# REVIEW NOTES
# ROCHESTER BRF 0162(16) & (17) – BRIDGES 15 & 16
# PRECAST FABRICATION DRAWINGS
# April 8, 2014

**RE:** Precast Fabrication Drawings received from Schultz Construction on 3/17/2014 (drawings dated 3/14/2014).

**VHB Project No.:** 57526.00 & 57527.00

1 / F1 PRECAST CONCRETE ABUTMENT AND WINGWALL LAYOUT

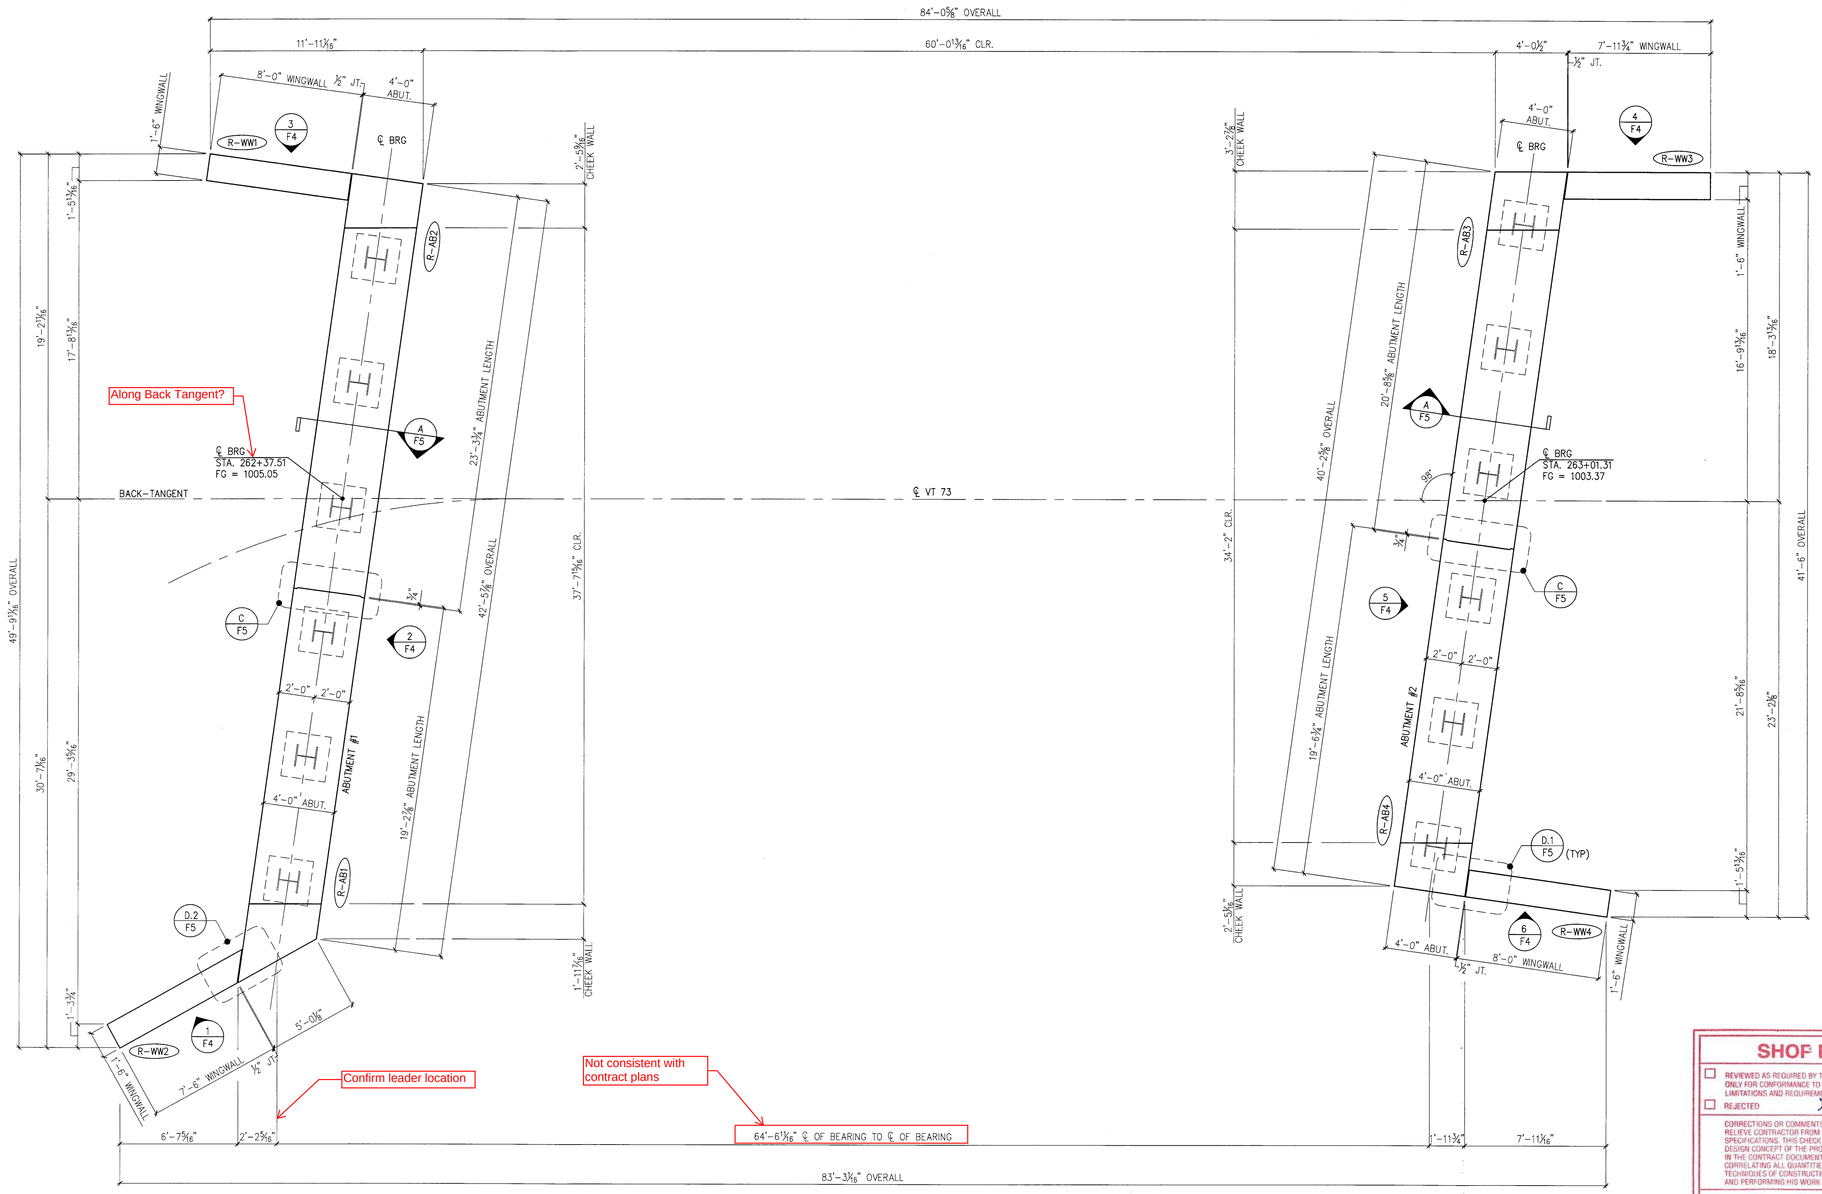
SUBSTRUCTURE PLANS?

A / F5 BEARING SECTION
NEXT BEAM STEM BEARING 3/4" =1'-0"

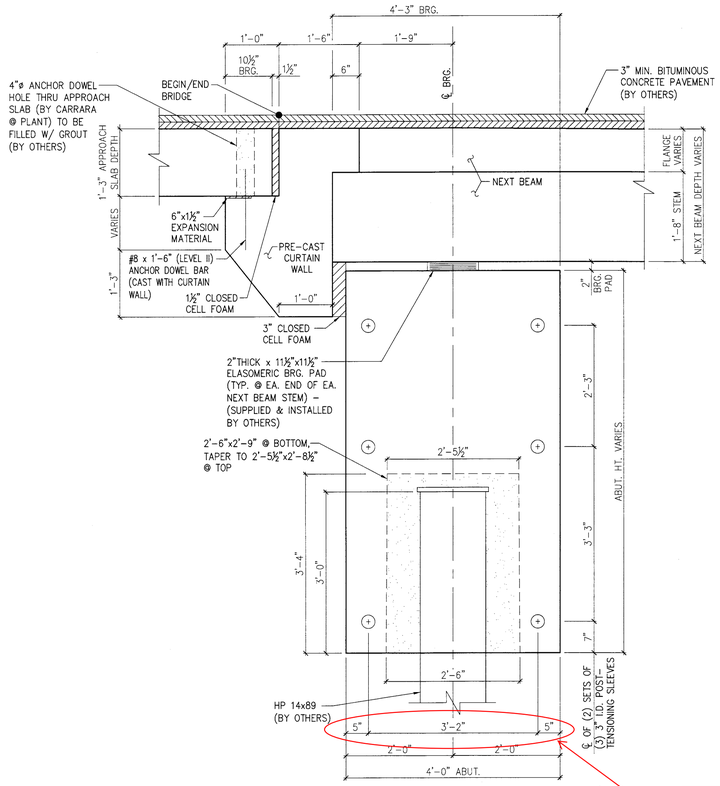
Revise dimensions, do not match sheet AB1

D.2 / F5 WING WALL CONNECTION DETAIL
1" =1'-0"

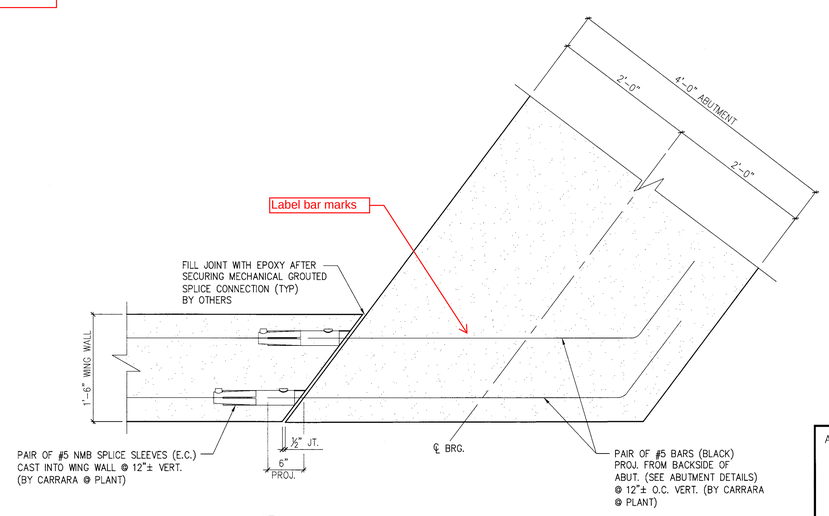
The anchorage assembly should be epoxy painted after installation.

2 NB1 REINFORCING PLAN VIEW IN FORM
ALL DIMENSIONS INDICATED ARE PARALLEL OR PERPENDICULAR TO ℄ OF STEMS U.N.O.
1/4" =1'-0"

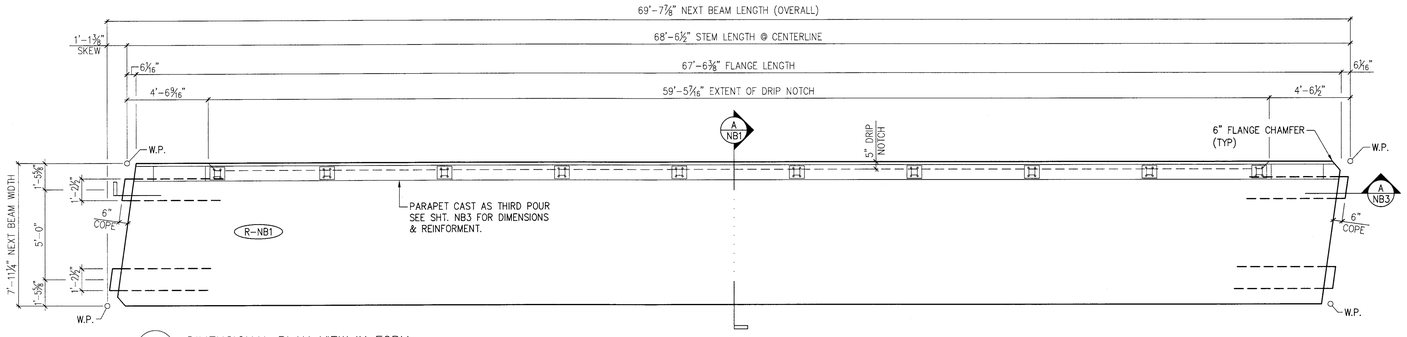
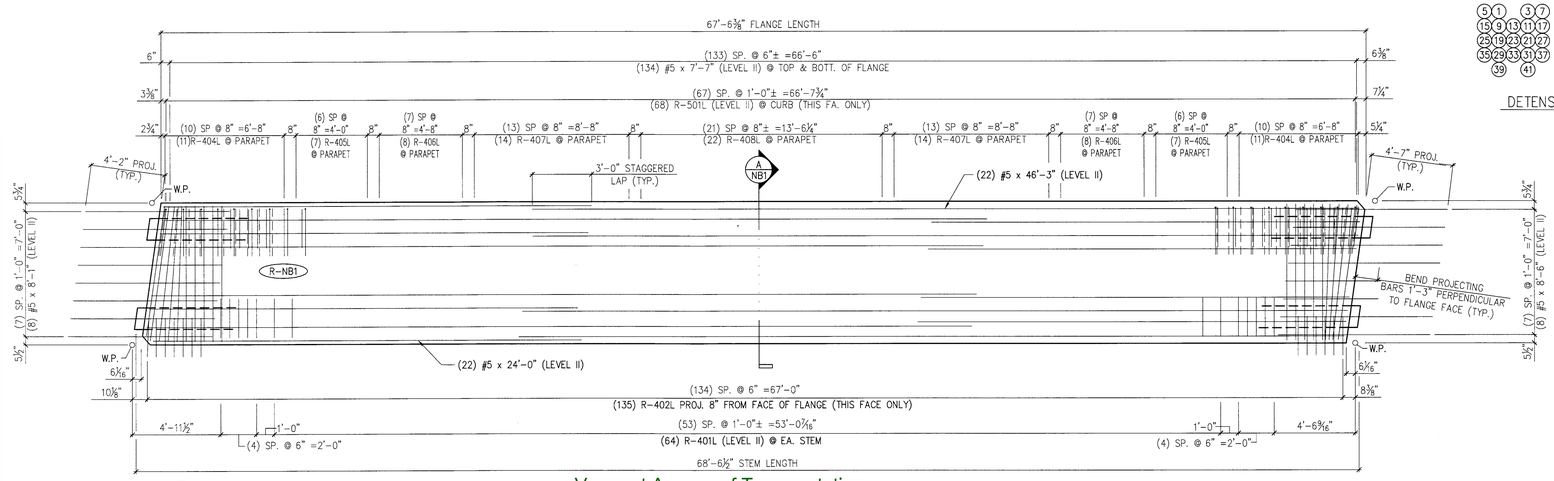
Is this point a fixed distance from top or truly centered? Dimension distance to indent in shear key.

Not consistent with PCI standard (typ)

Provide proper clearance according to contract plans

A NB1 DIMENSIONAL & REINFORCING SECTION
3/4" =1'-0"

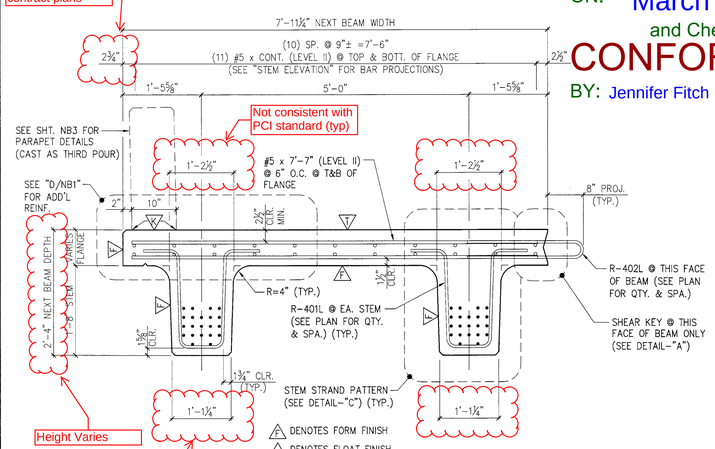
Verify roughening amplitude of this surface.

Verify quantities, and bars. Provide bent bar diagrams and schedule

A NB2 REINFORCING CURTAIN WALL ELEVATION @ ABUT. #1
3/4" =1'-0"

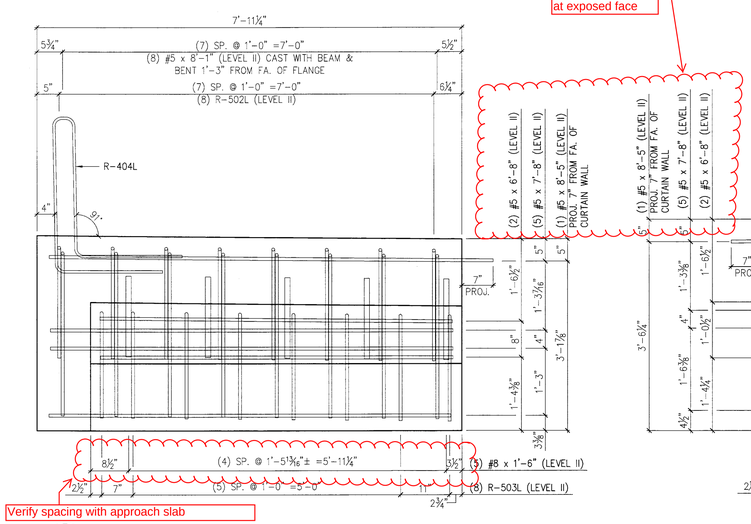
Confirm clearance at exposed face

Verify spacing with approach slab

A NB4 DIMENSIONAL & REINFORCING SECTION
3/4" =1'-0"

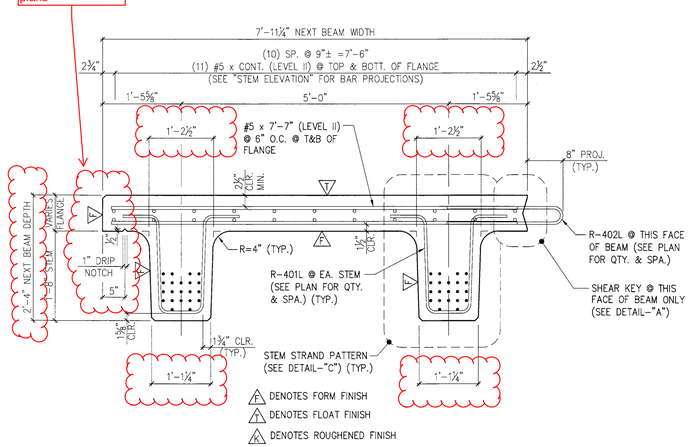
Verify with contract plans

Verify sheet number with detail

2 NB8 REINFORCING PLAN VIEW IN FORM
ALL DIMENSIONS INDICATED ARE PARALLEL OR PERPENDICULAR TO ℄ OF STEMS U.N.O.
1/4" =1'-0"

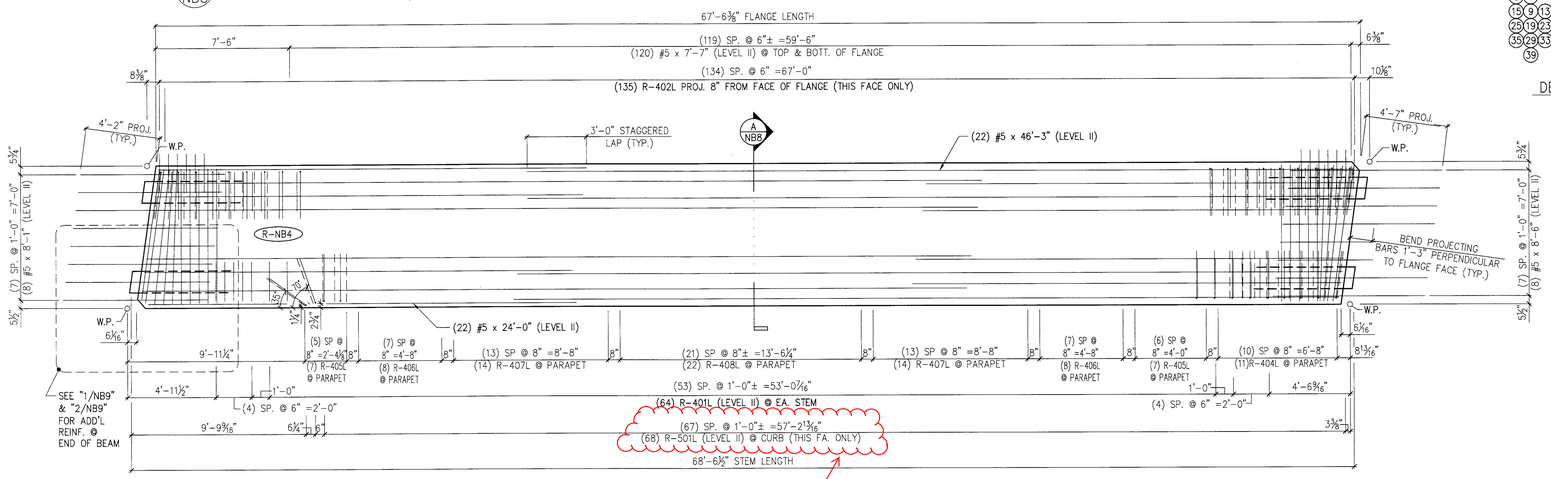
Verify quantity and spacing with sheet NB9

A NB10 REINFORCING CURTAIN WALL ELEVATION @ ABUT. #1 3/4" =1'-0"

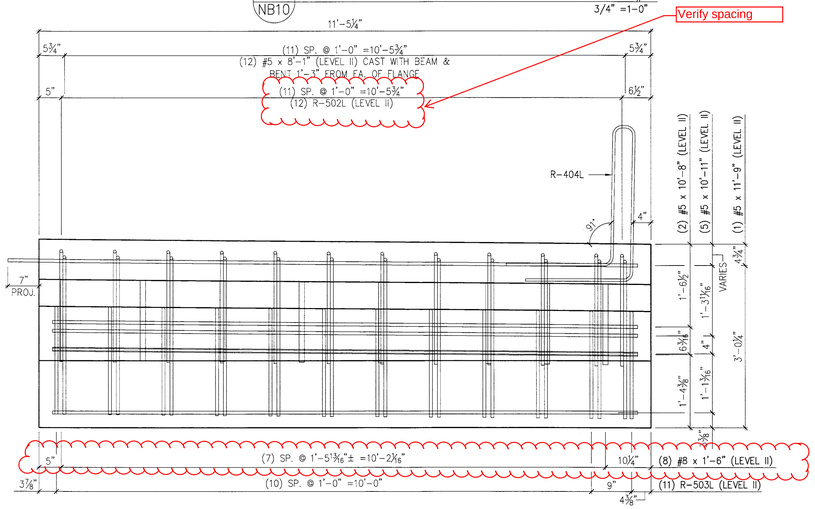
Verify spacing

B NB10 REINFORCING CURTAIN WALL ELEVATION @ ABUT. 3/4" =1'-

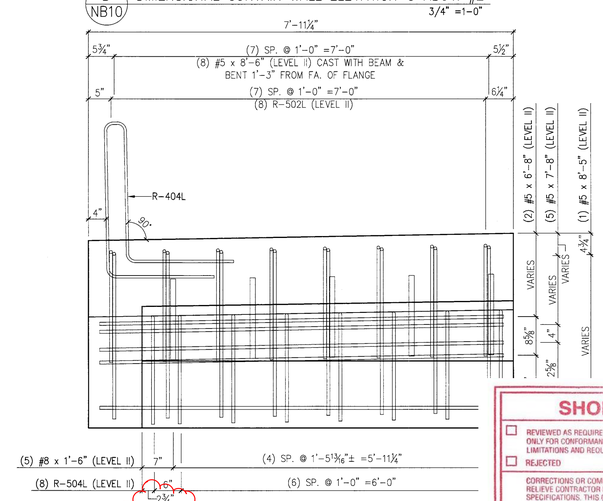
Verify clearance

2 AB2 ABUTMENT DIMENSIONAL PLAN VIEW IN FORM
3/8" =1'-0"

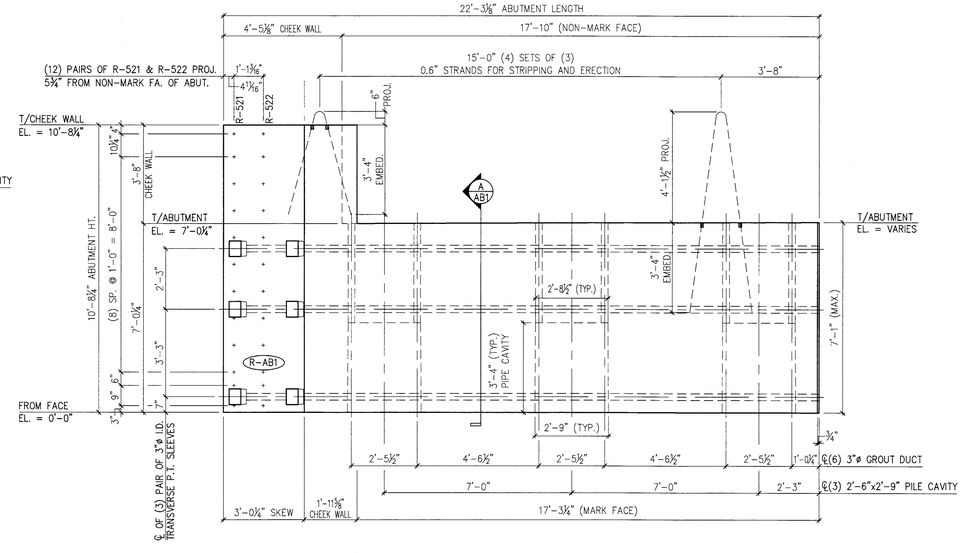
Elevation View? (typ)

A WW1 WING WALL SECTION
3/4" =1'-0"

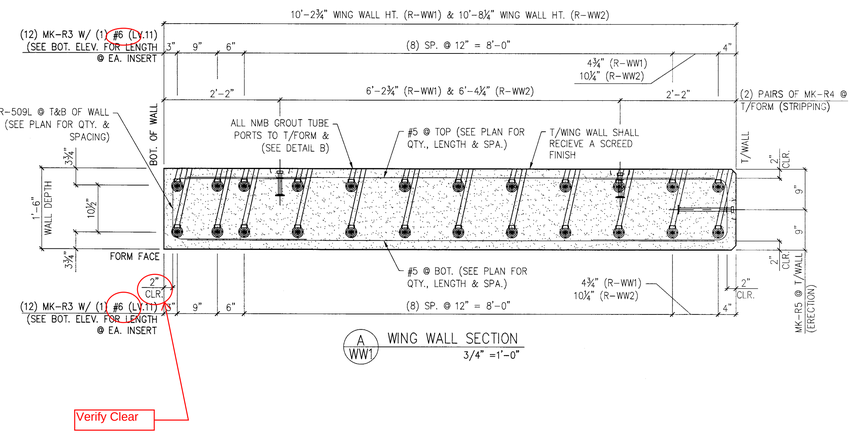
Verify Clear

#5? Not consistent with abutment drawings and contract plans

Verify

Add additional skewed bar

Where is detail A|WW2?

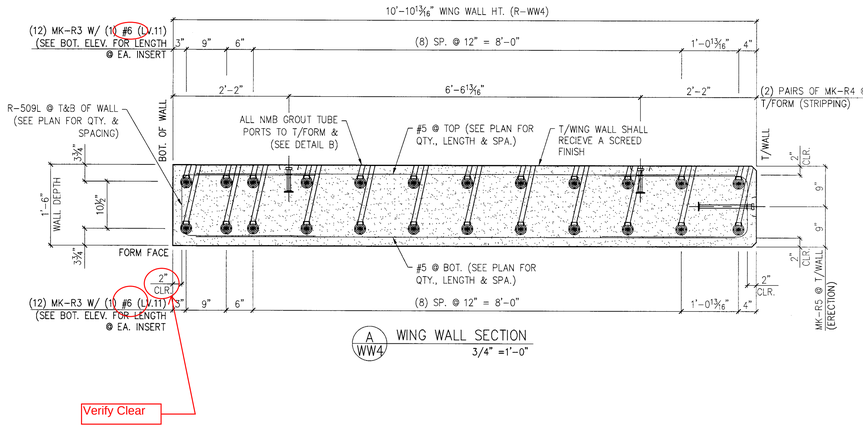
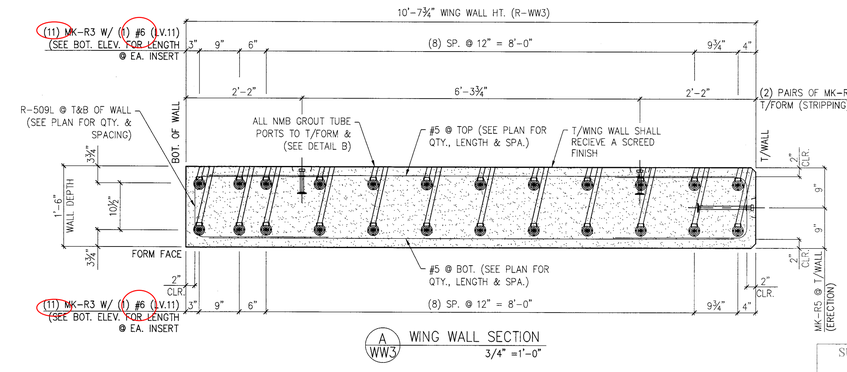
#5? Not consistent with abutment drawings and contract plans

Verify

Add additional skewed bar

PRECAST APPROACH SLABS

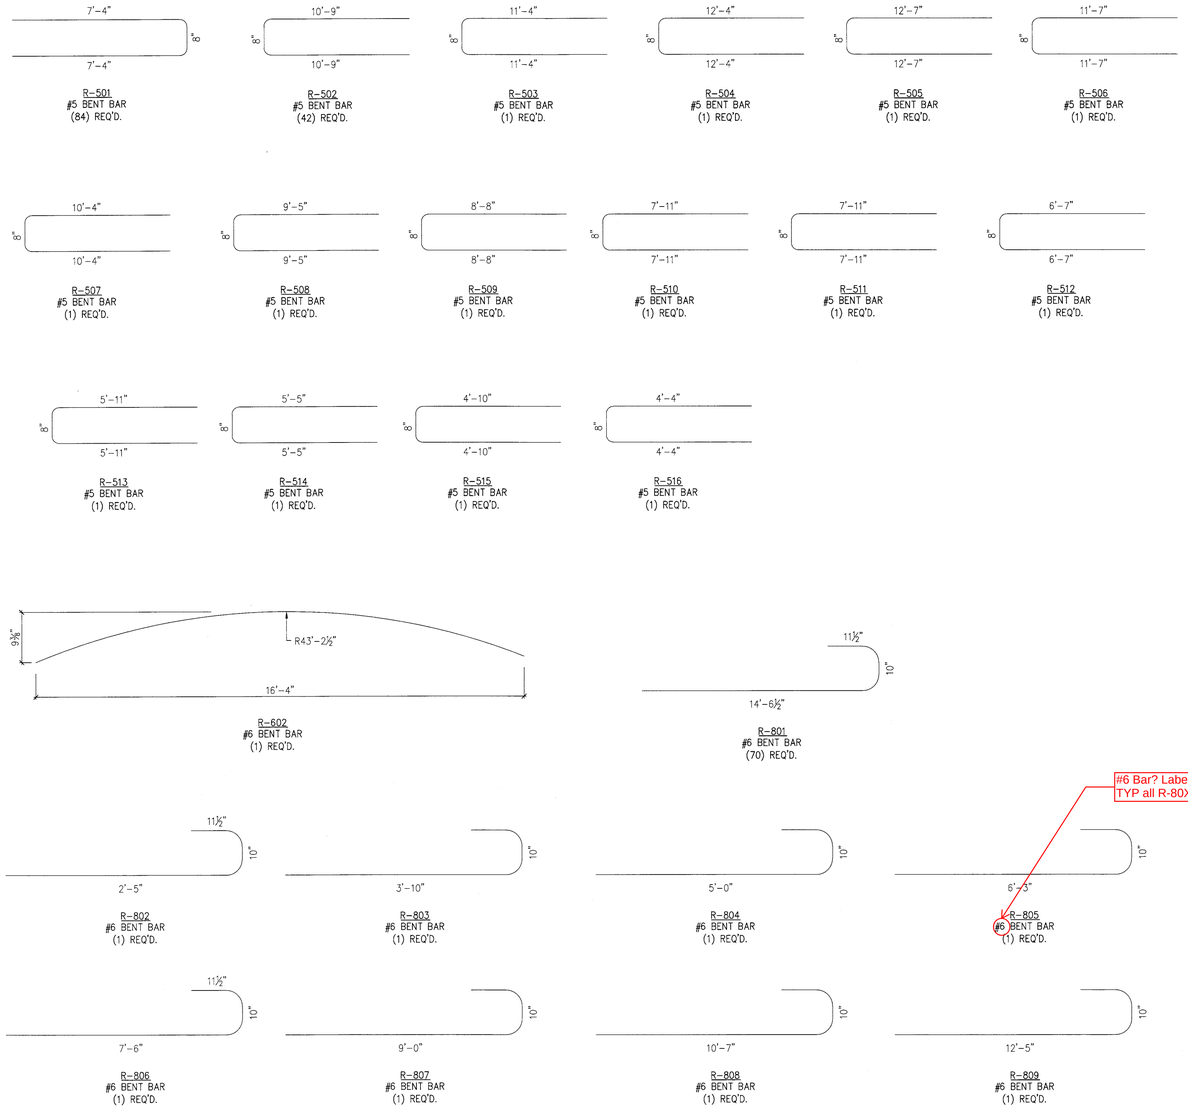
#6 Bar? Labeled as R-805. TYP all R-80X bars
